# UNITED STATES PATENT AND TRADEMARK OFFICE

APPLICATION NO.	FILING DATE	FIRST NAMED INVENTOR	ATTORNEY DOCKET NO.	CONFIRMATION NO.
10/660,611	09/12/2003	Chun Ho Fan	50626.55	6110

**Office Action Summary**

## DETAILED ACTION

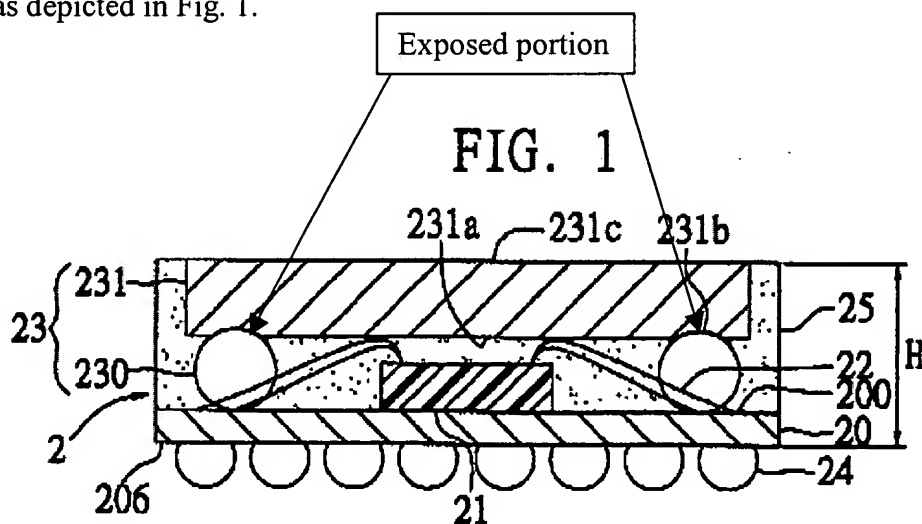
Applicants argue that “Huang et al. certainly fails to teach or suggest the feature of *an overmold material encapsulating said semiconductor die and said balls on said substrate such that portions of said balls that are disposed farthest from said substrate are exposed at an exterior of said Integrated circuit package...*”

In response to applicants’ contention, it is respectfully submitted that Huang et al. ’0113308 disclose all the claimed limitations including “overmold material encapsulating said semiconductor die and said balls on said substrate such that portions of said balls that are disposed farthest from said substrate are exposed at an exterior of said Integrated circuit package,” as depicted in Fig. 1.

As shown above, the exposed portion of the balls 230 is at exterior portion of the package which is farthest from the substrate 20. In addition the heat sink 231 is in contact with the exposed portion of balls 230 and the overmold material 25 also encapsulating the semiconductor die 21 and the balls 230. Furthermore, the semiconductor die 21 is electrically connected to solder balls 24 for external connection via through conductive traces 22 (see Page 2, Paragraph 0024).

Therefore, the rejection of claims 13, 15- 17, 20-22, 24 and 25 under 35 U.S.C. § 102(b) is deemed proper. In addition, the rejection of claim 23 under 35 U.S.C. § 103(a) is deemed proper and the *prima facie* case of obviousness has been met.
